ADDENDUM NO. 2

PROJECT: UNT Kerr Hall Dining Renovation
HE0569.2302.01

DATE: 05/23/2025

1 LEVEL 1 ELECTRICAL PLAN - DINING
1/8" = 1'-0"

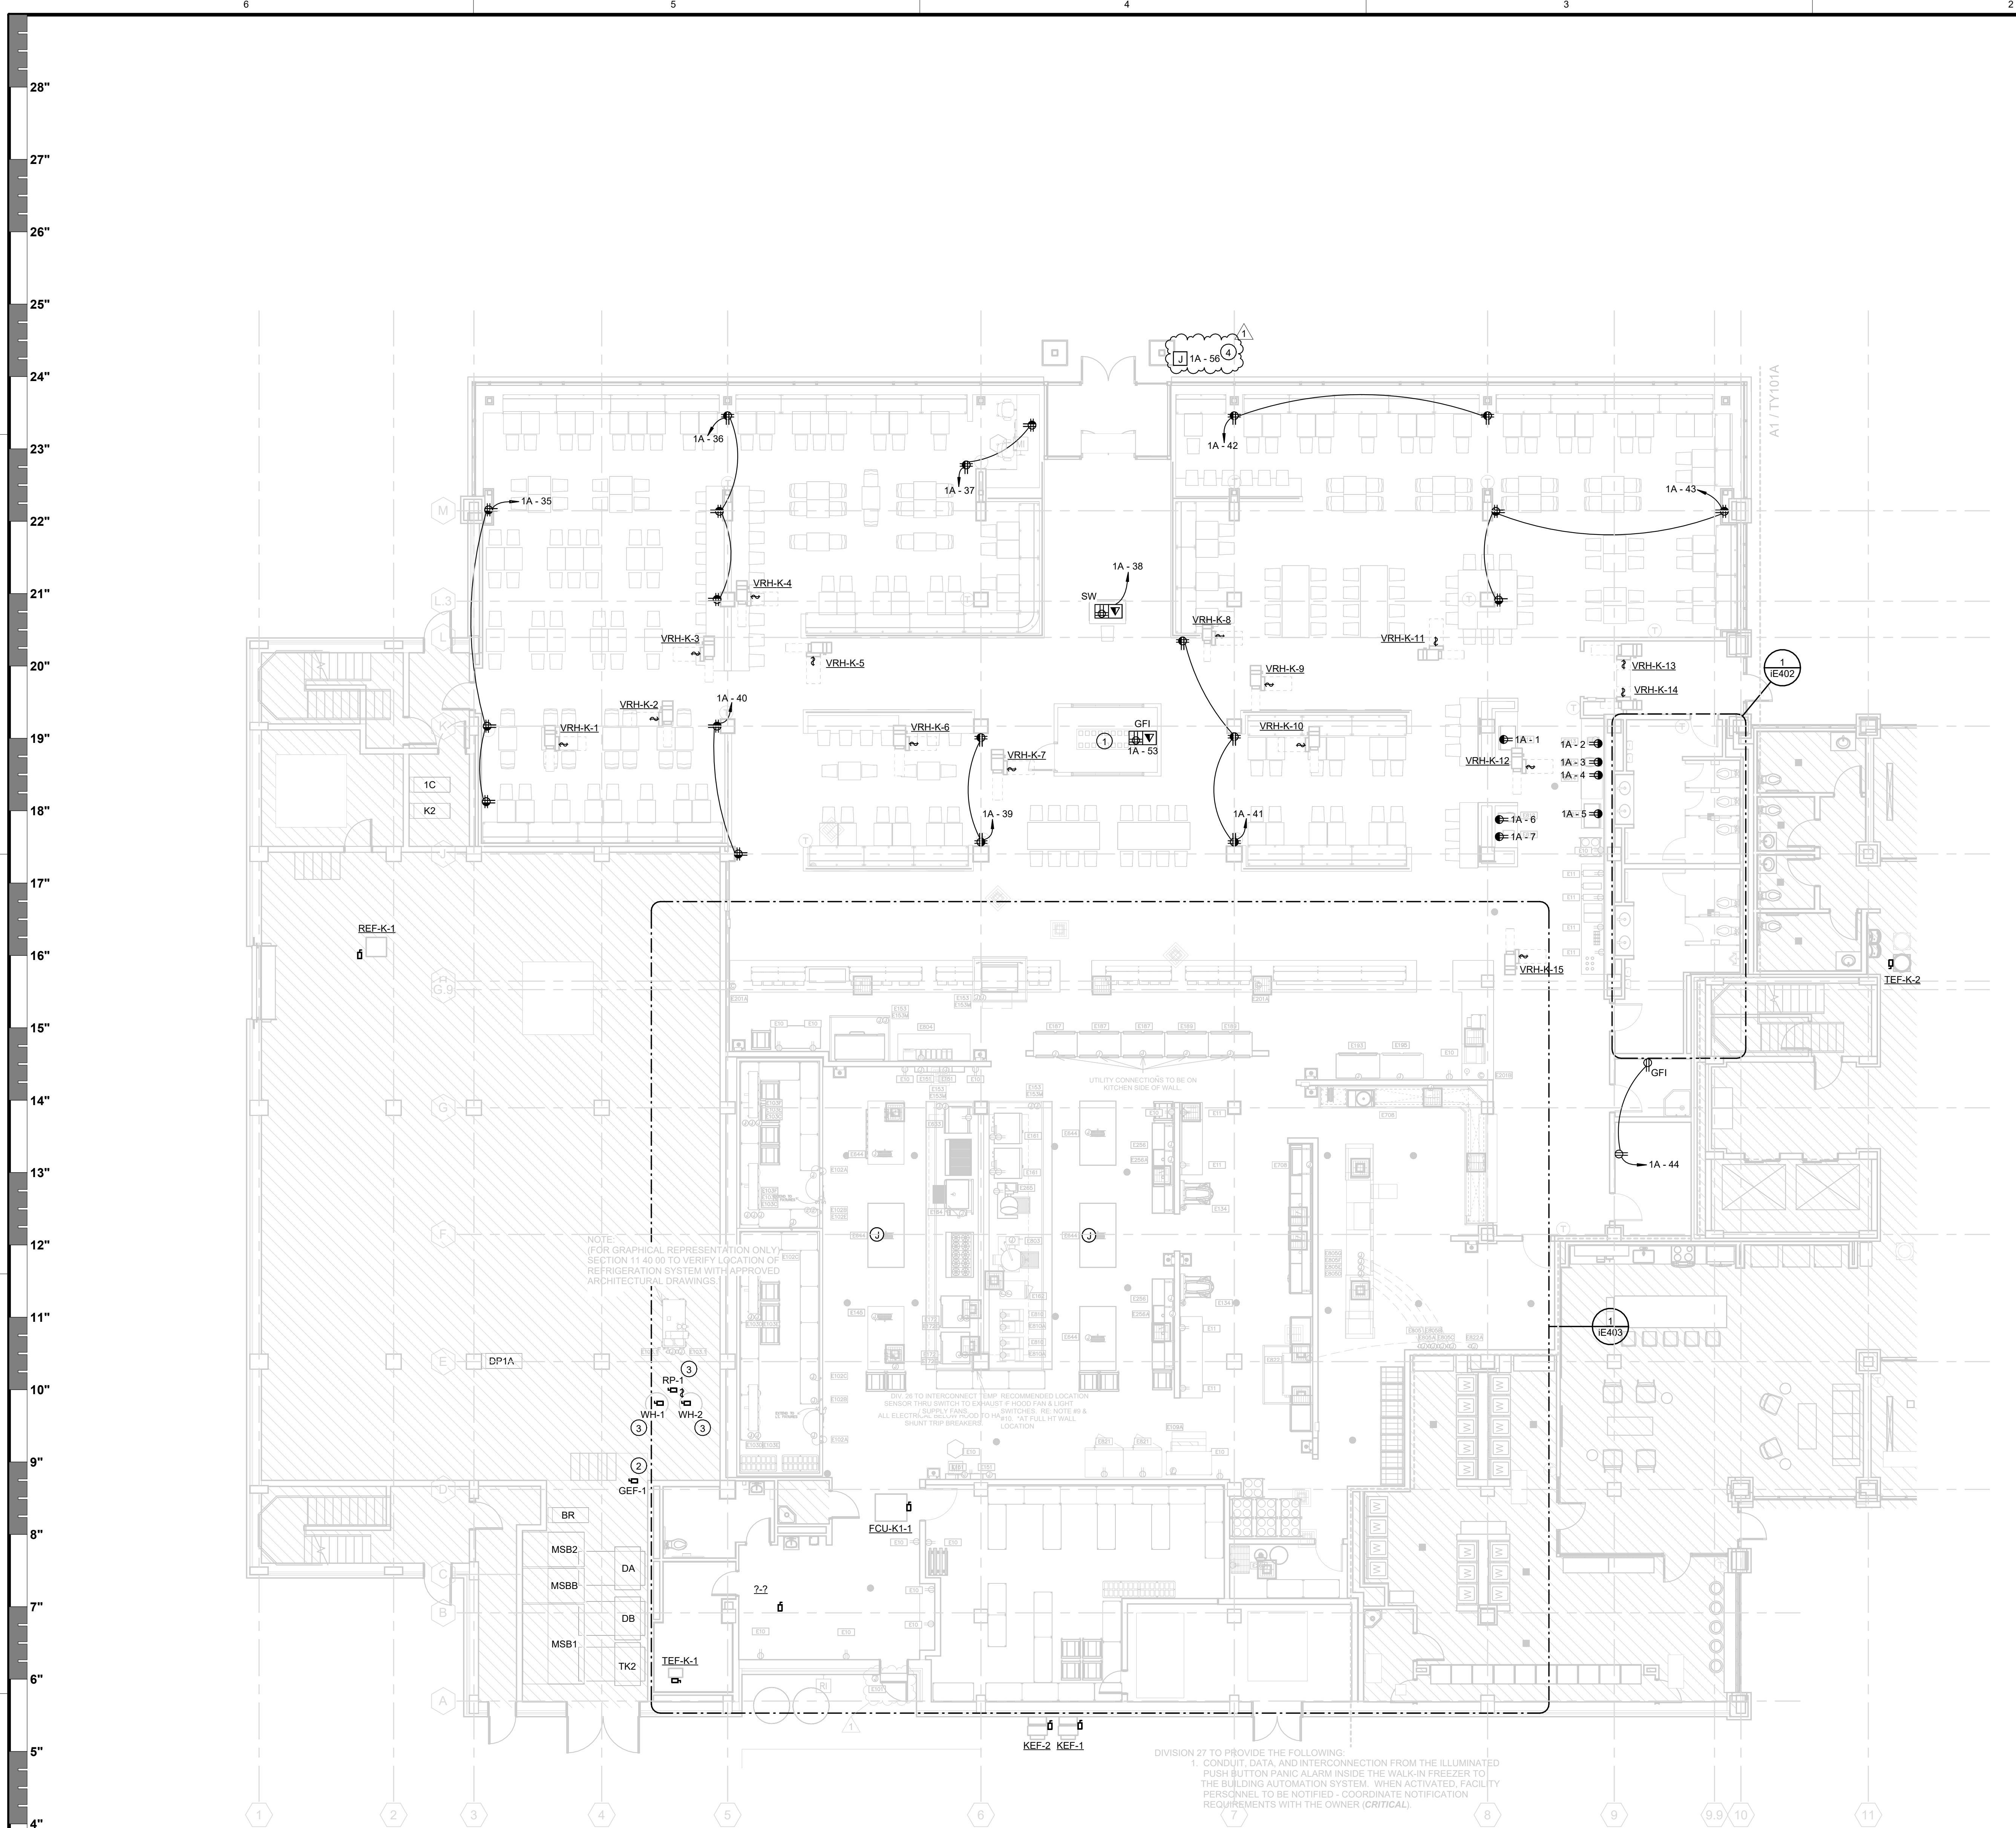
- ADDED JUNCTION BOX FOR INTEGRALLY-LIT EXTERIOR SIGN.
- ADDED KEYED NOTE 4.

1 LEVEL 1 LIGHTING PLAN - DINING
1/8" = 1'-0"

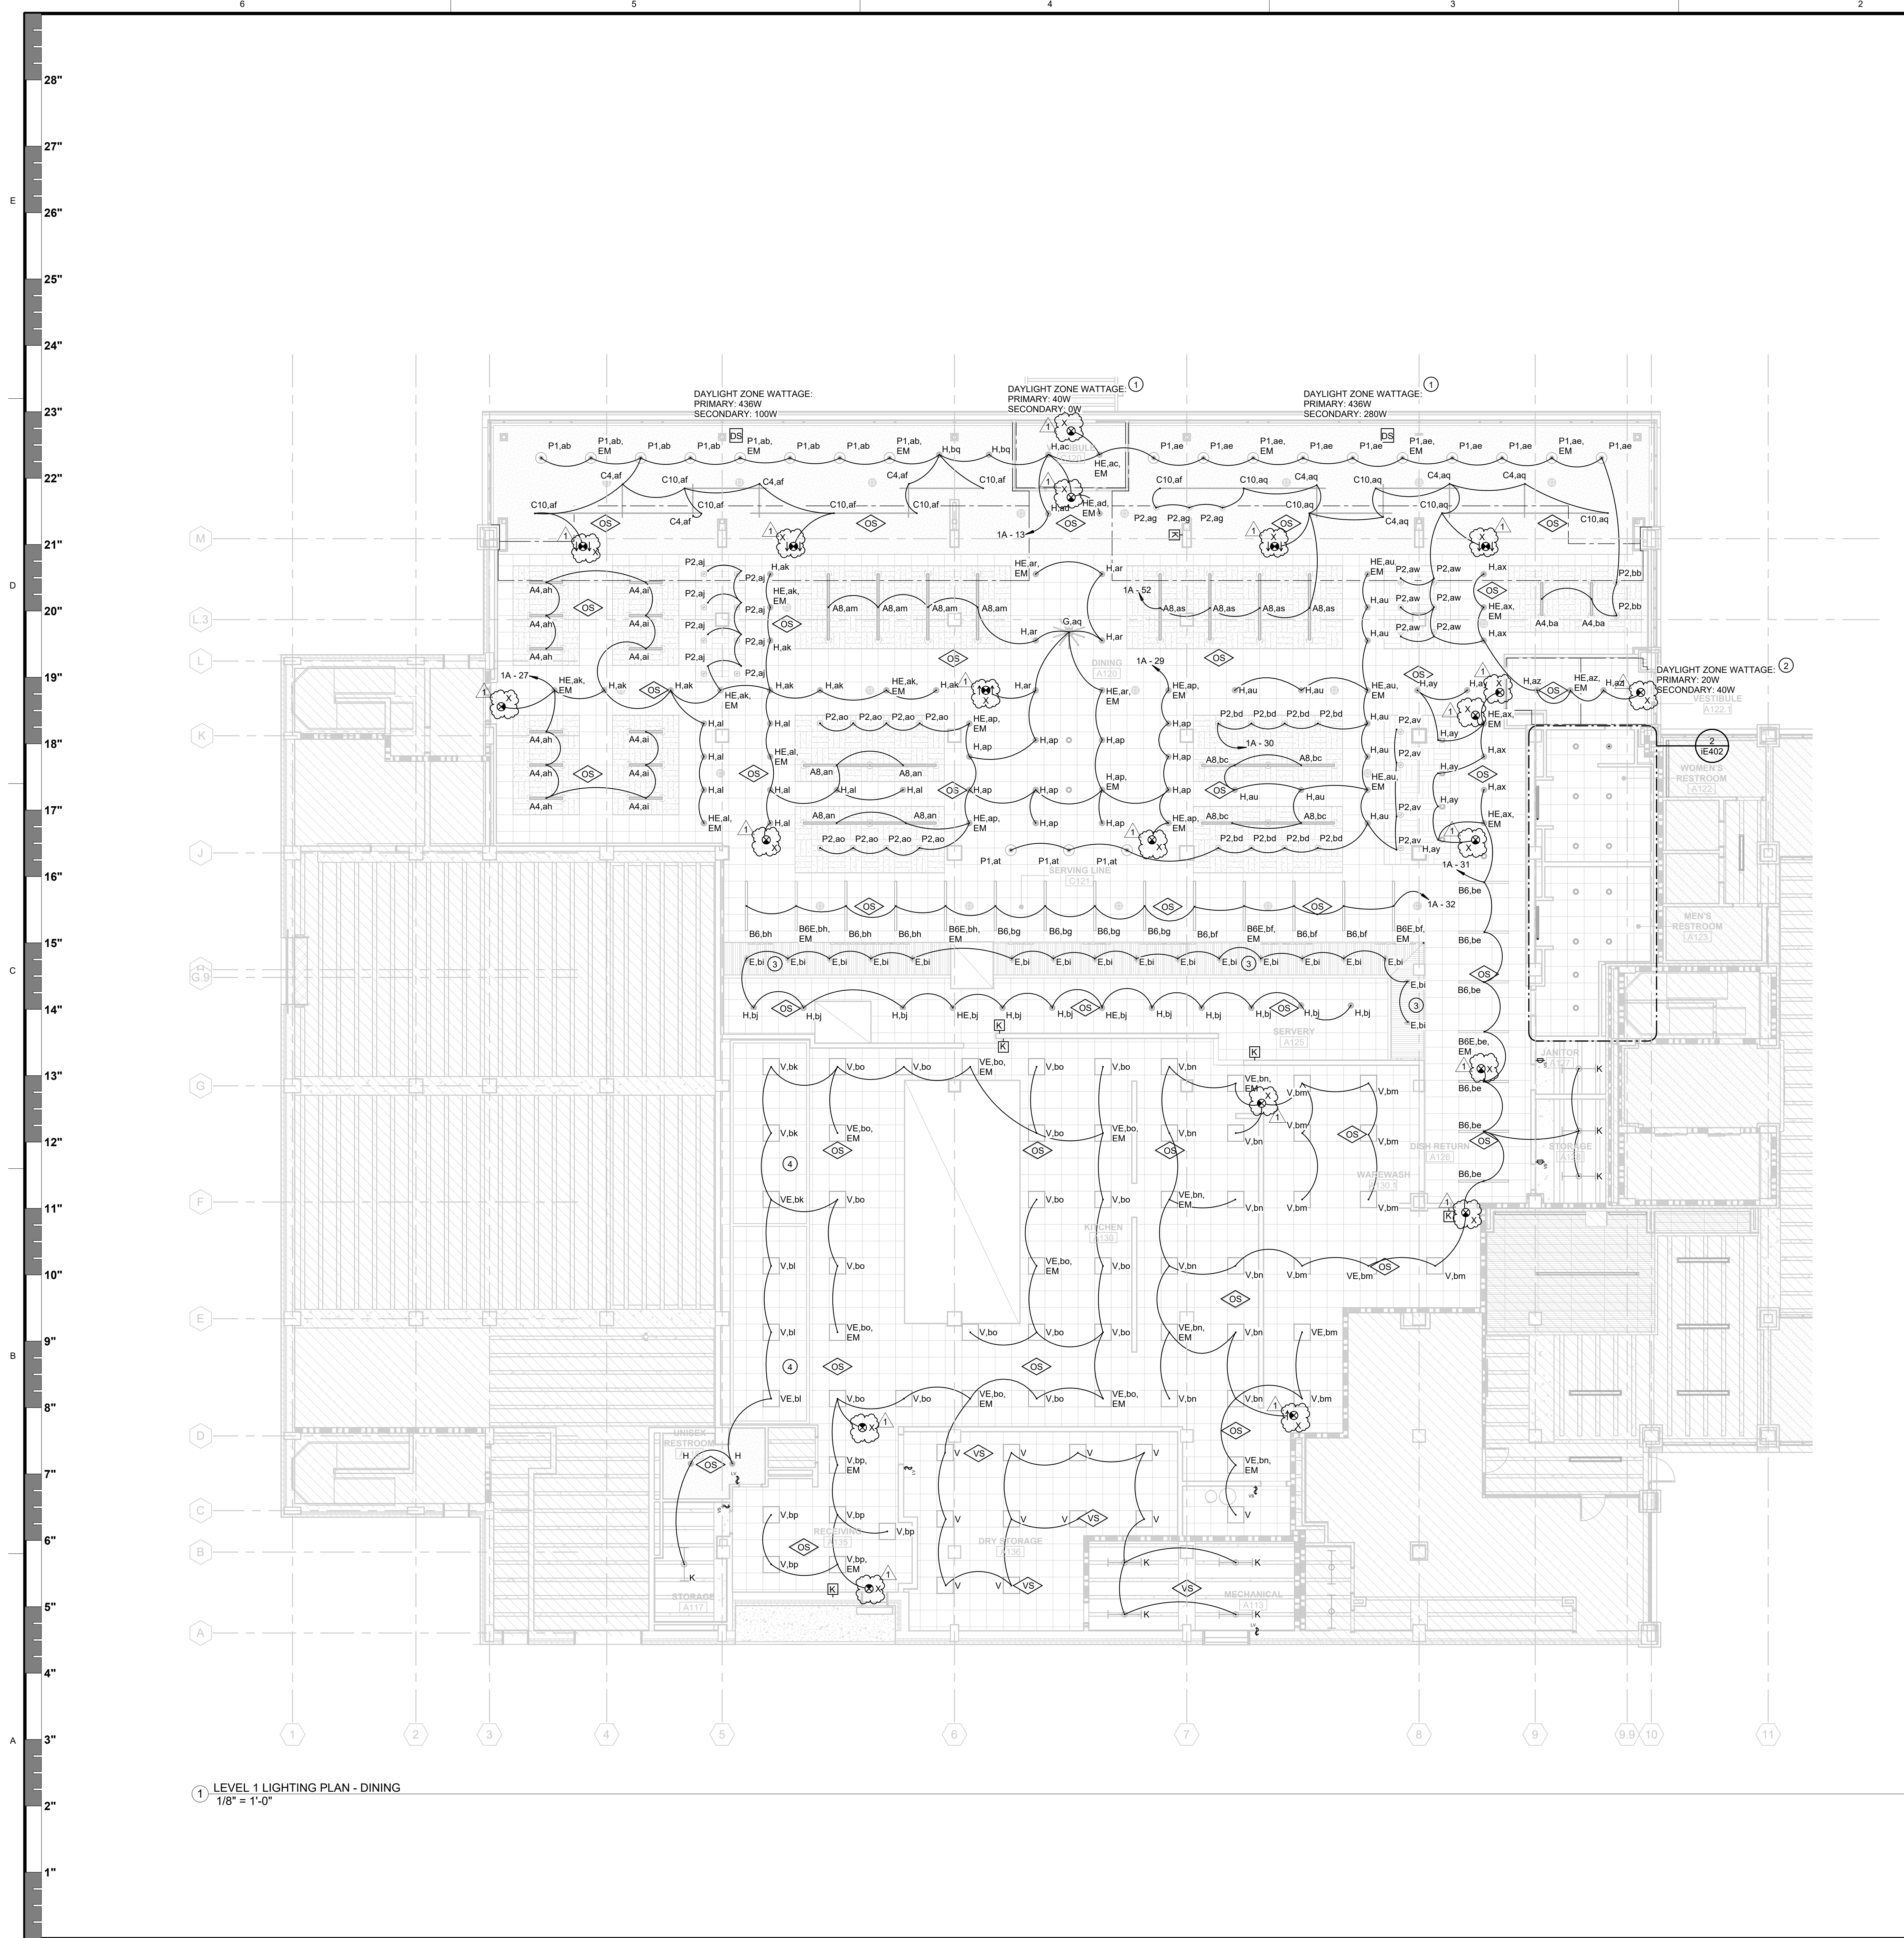
- REVISED TYPE KE FIXTURES TO TYPE X.
- ADDED DEMO SCOPE NOTE.
